Lot 909, 12 Chalk Street, Wooloowin – Response to Further Advice Notice – Traffic and Transport items

This letter has been prepared to provide a transport response to the traffic related items included within the Further Advice notice, specifically, **item 1(c), item 7 and item 8** of Council's Further Advice notice letter. For reference, Council's items have been reproduced below, with Urbis' response following each item.

Attachment A – Council Further Advice Notice

Figure 1 – Development West Elevation

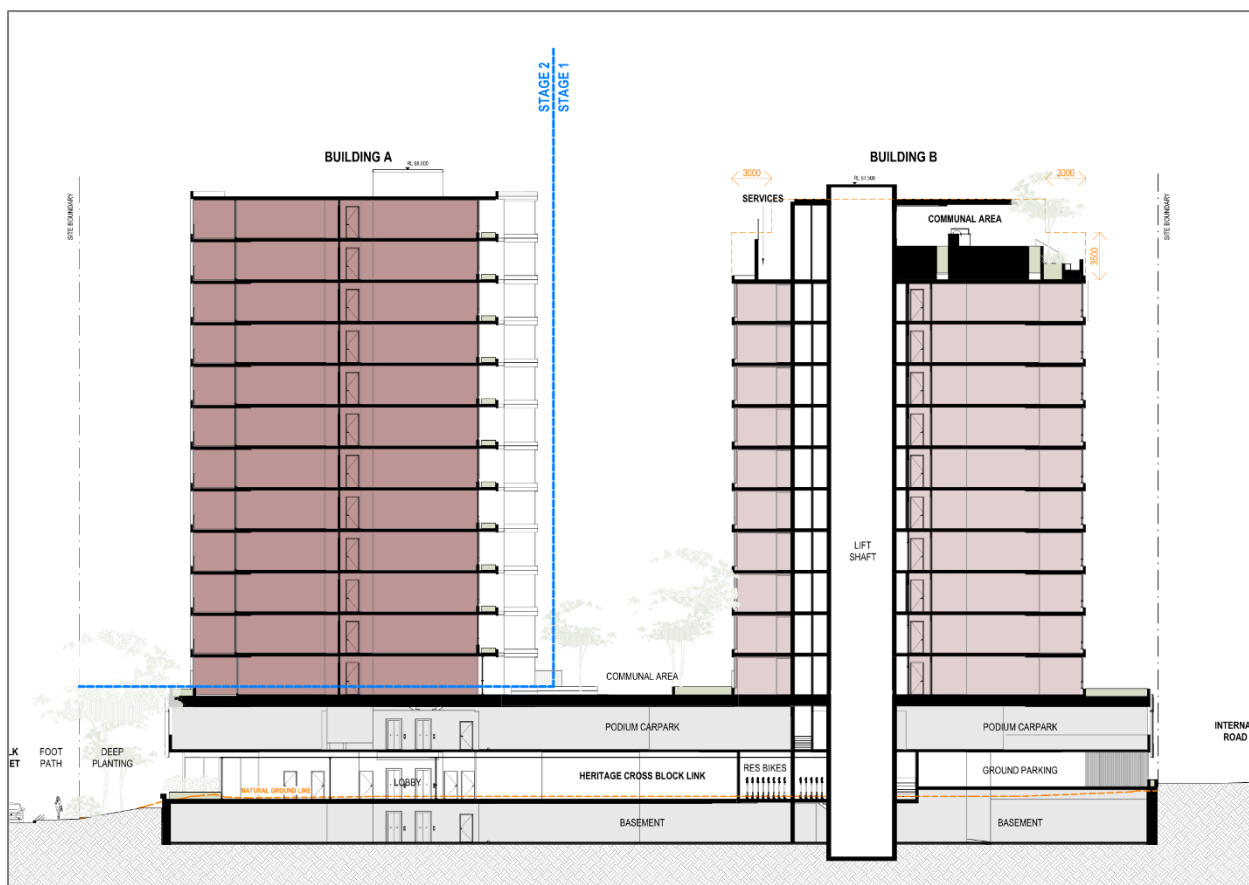
- (c)** A full set of architectural plans that demonstrate the proposed staging lines, order and functionality between stages. The architectural plans are to include:
 - i.** A clear staging line that does not intersect key aspects of the development which are required for the function of Stage 1 or results in the part-delivery of elements in Stage 2. NB: the current Architectural plans detail the staging line through carparks and balconies, which is does not clearly illustrate how these spaces will be delivered.
 - ii.** An individual sets of plans for each of the stages proposed. The Stage 2 set should detail the earlier stage to demonstrate the interaction and removal of any temporary works.

- iii. Detail of the interim treatment between stages. NB: It is noted that the amended plans did not clearly reflect all outcomes detailed within the written response.
- iv. Demonstration of parking, access, servicing and manoeuvring arrangements whereby an interim solution is proposed between stages. NB: See 'Carparking and manoeuvring' section of this letter for further information regarding this component.
- v. Demonstration of how the stages will operate on their own during construction (e.g. any temporary walls proposed to basements until the construction of the next stage commences). They should also demonstrate what other stages will look like during construction (e.g. is excavation of the basement levels to occur at the same time as each other or will the Stage 2 remain as vacant land until the Stage 1 is completed).

A revised staging line has been proposed within the architectural plans which includes all carparking, servicing and manoeuvring areas to be delivered in their entirety as part of Stage 1. The revised staging arrangements have been demonstrated within Figure 1, and provided within the architectural plans provided in **Attachment B**.

With consideration of the revised staging, these arrangements do not impact or intersect any parking, access, servicing or manoeuvring arrangements, nor are any interim treatments proposed within these areas prior to the delivery of stage 2 (including construction of Stage 2).

Figure 2 – Temporary Visitor Bicycle Parking Relocation

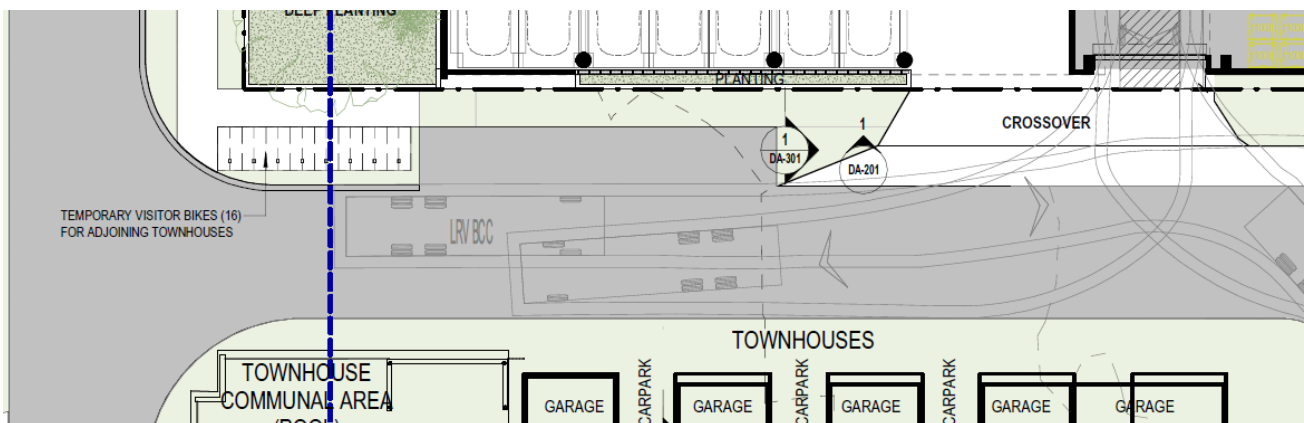
The response to the Information Request has not demonstrated where the existing visitor bicycle parks within the internal road are proposed to be relocated to. Provide amended plans showing where the existing bicycle parking are proposed to be relocated to, ensuring that they maintain compliant visitor bicycle parking rates, in accordance with the requirements of the Transport access parking and servicing code.

NB: Whereby the temporary bicycle parking spaces are not provided as required by the conditions of a previous approval over the site, then a Change Application to that previous approval will be required.

It is noted that the temporary visitor bicycle parking spaces provided along the internal road (provided in 8 hoops to service the adjacent townhouses) are impacted by the proposed crossover and have been

relocated to the west of the kerbside parking module (as demonstrated in Figure 2 below). The revised location is considered suitable to service the existing townhouses.

DRAWING NAME
WEST ELEVATION

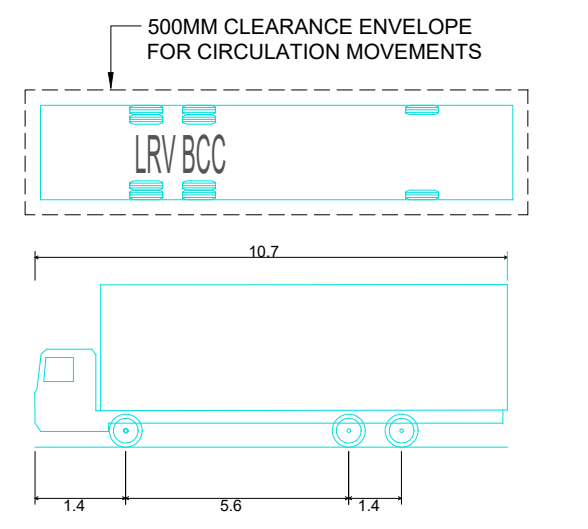
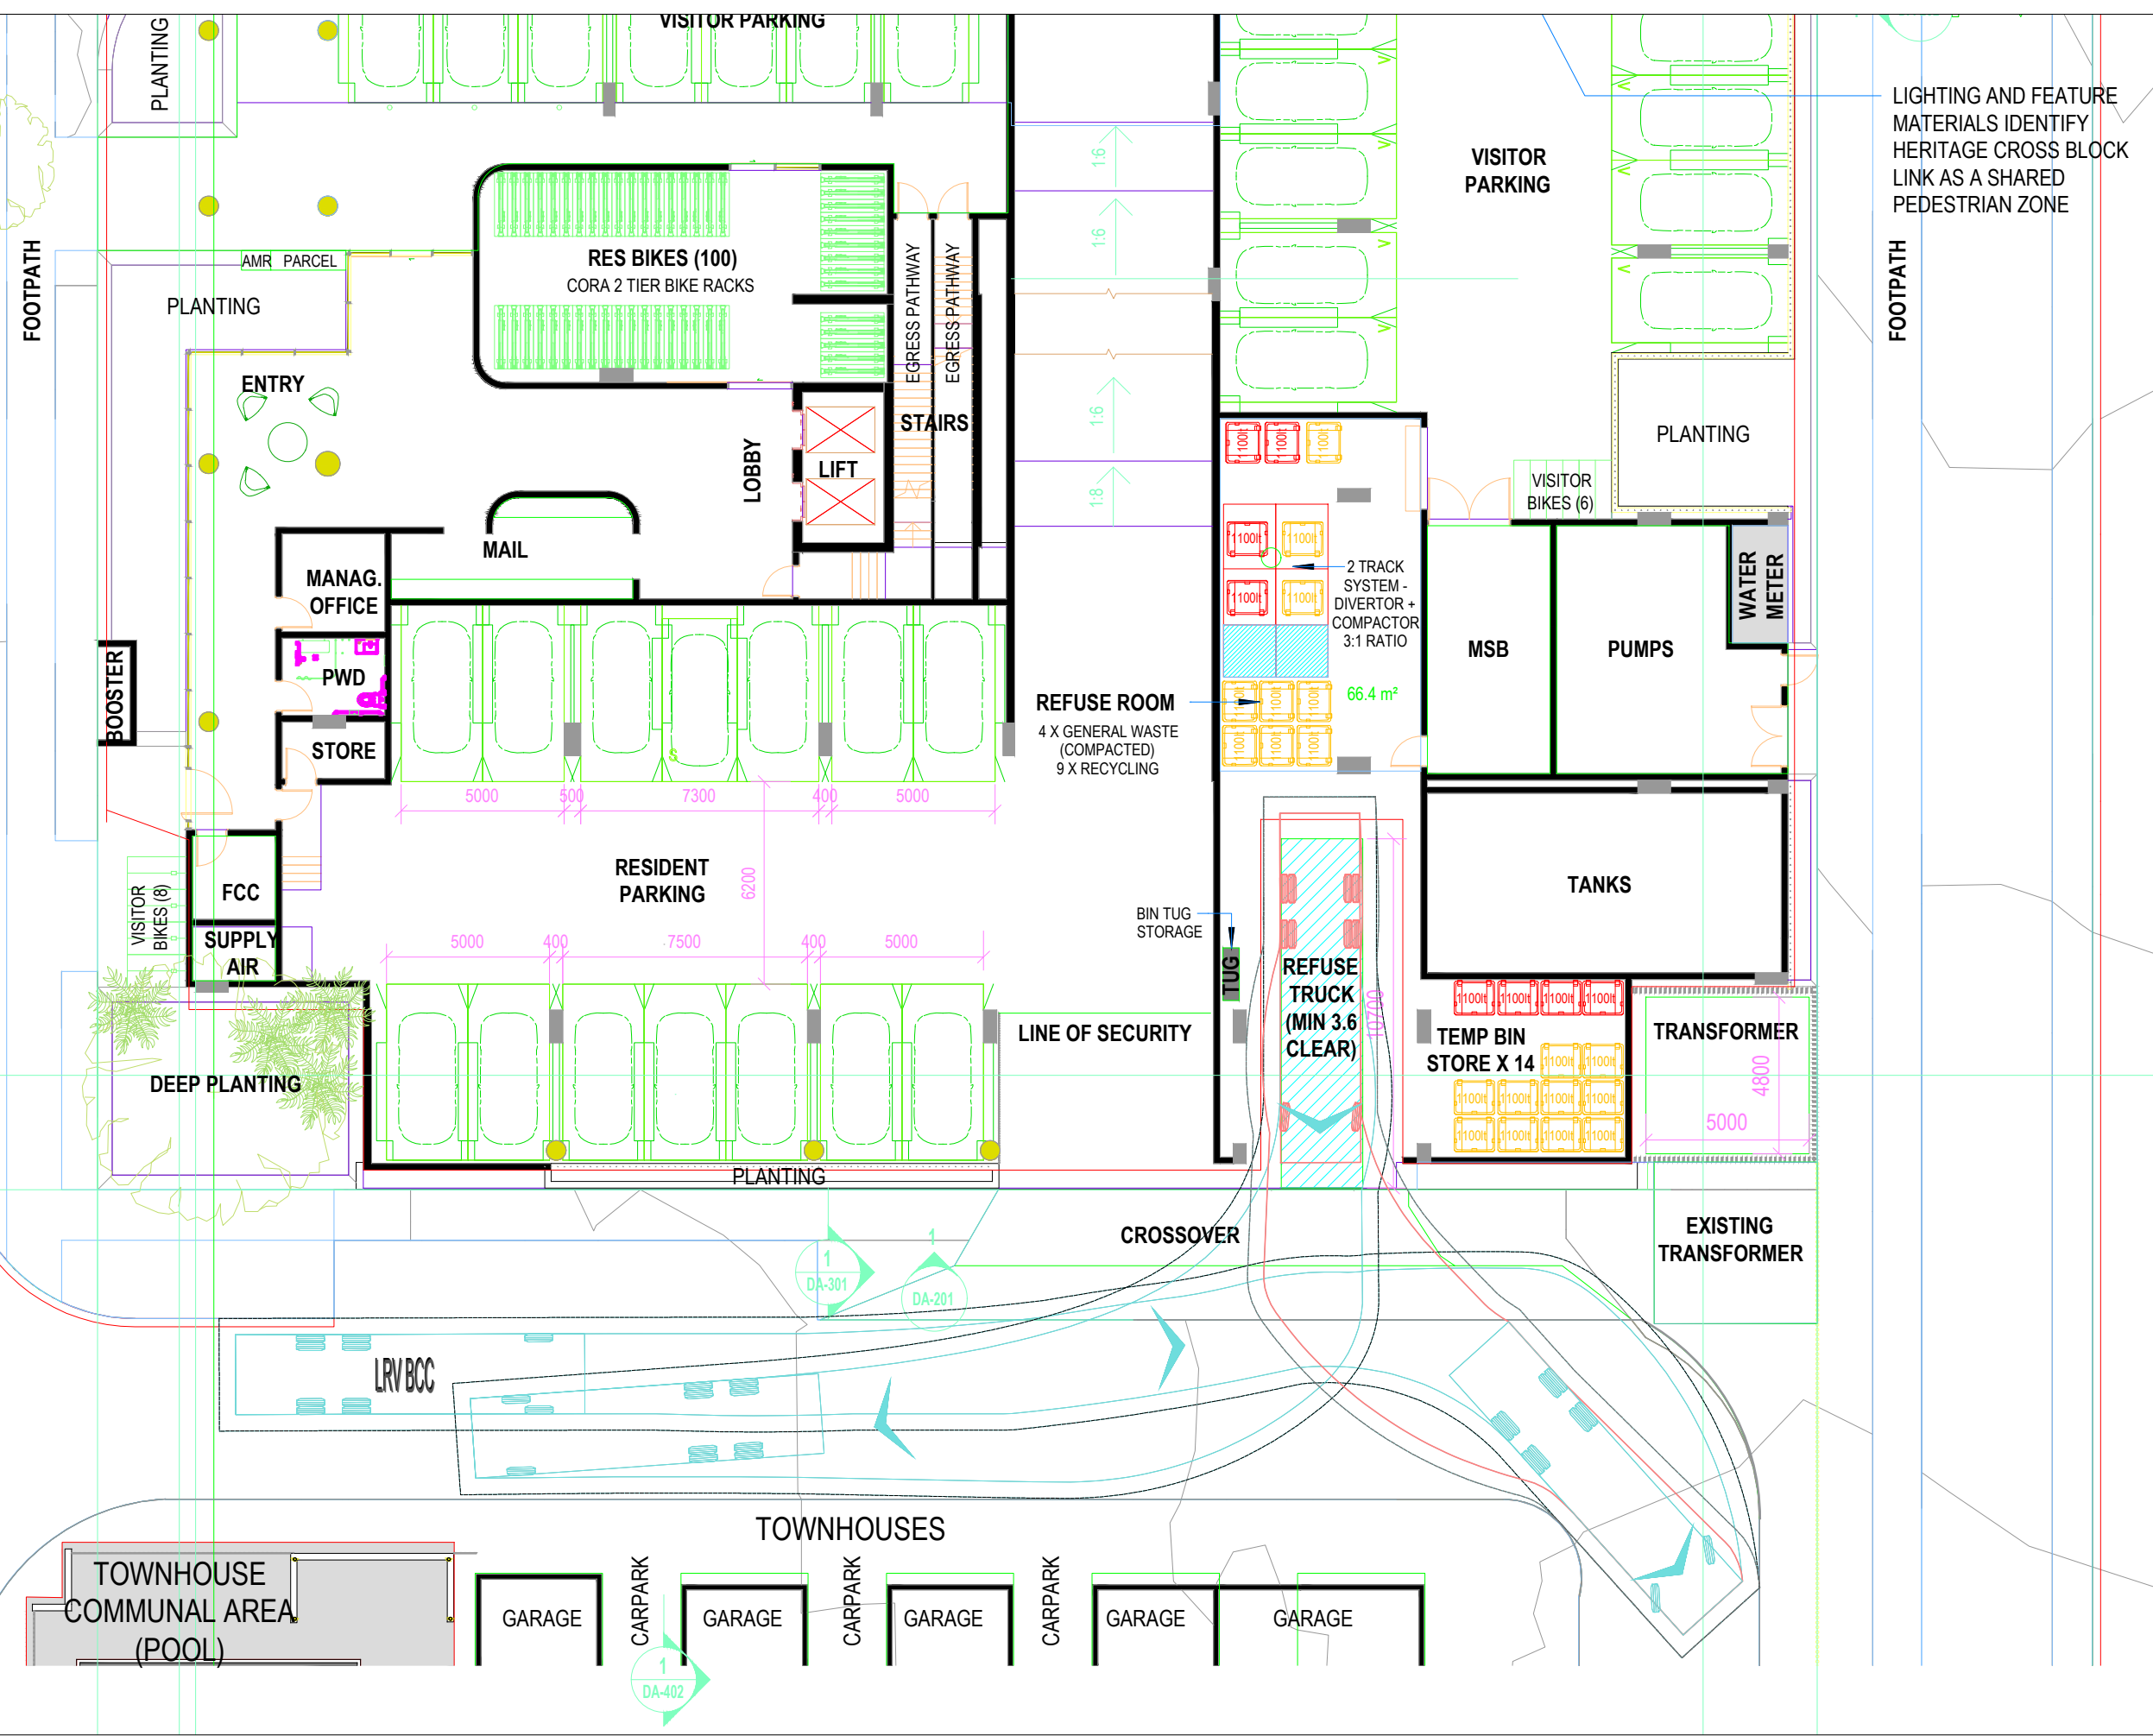
- i. A clear staging line that does not intersect key aspects of the development which are required for the function of Stage 1 or results in the part-delivery of elements in Stage 2. **NB:** *the current Architectural plans detail the staging line through carparks and balconies, which is does not clearly illustrate how these spaces will be delivered.*
